Access Compliance Report

Public Rights-of-Way

Intersection ID: 22417	Main Street: BRACKENBURY_LN	Cross Street: N_BRACKENBURY_LN	Location: E
ADA ID: E8EF15ACDCF0	Ramp Type: PerpDiag	Initial Pass/Fail: Fail	Overall Compliance: No
		Severity Score: 10

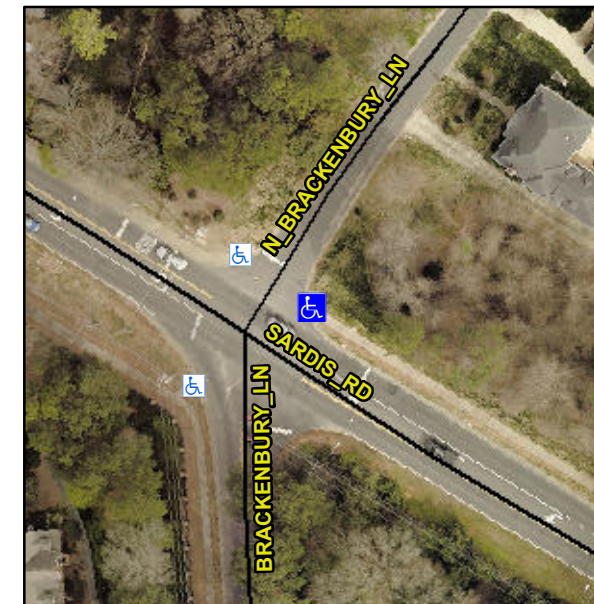
Not Found, R304.5.1, R304.5.3

Compliance	Description	Data	Compliance	Description	Data
N/A	Ramp Length (in)	60.0	Yes	Ramp Slope (%)	6.0
No	Ramp Width (in)	46.0	No	Ramp XSlope (%)	3.5
N/A	Flare Type LT	N/A	N/A	Flare Type RT	N/A
N/A	Flare Slope LT (%)	N/A	N/A	Flare Slope RT (%)	N/A
N/A	Flare Traversable LT?	N/A	N/A	Flare Traversable RT?	N/A
N/A	Landing Length (in)	N/A	N/A	DWS Provided?	N/A
N/A	Landing Width (in)	N/A	N/A	DWS Contrast?	N/A
N/A	Landing Slope (%)	N/A	N/A	DWS Length (in)	N/A
N/A	Landing X Slope (%)	N/A	N/A	DWS Full Width?	N/A
N/A	Landing Curb? (Y/N)	N/A	N/A	DWS Offset (in)	N/A
N/A	Shared Landing?	N/A			
N/A	Gutter Ponding?	N/A	N/A	Gutter Slope (%)	N/A
N/A	Gutter Lip Ht (in)	N/A	N/A	Gutter X Slope (%)	N/A
N/A	Painted X Walk1?	No	N/A	Painted X Walk2?	No
	X Walk 1 Direction	To NW		X Walk 2 Direction	To SW
N/A	X Walk 1 Width (in)	N/A	N/A	X Walk 2 Width (in)	N/A
	X Walk 1 Slope (%)	1.2		X Walk 2 Slope (%)	3.5
	X Walk 1 X Slope (%)	3.7		X Walk 2 X Slope (%)	2.7

Remove & Replace Curb Ramp With Two New Directional Ramps or Equivalent.
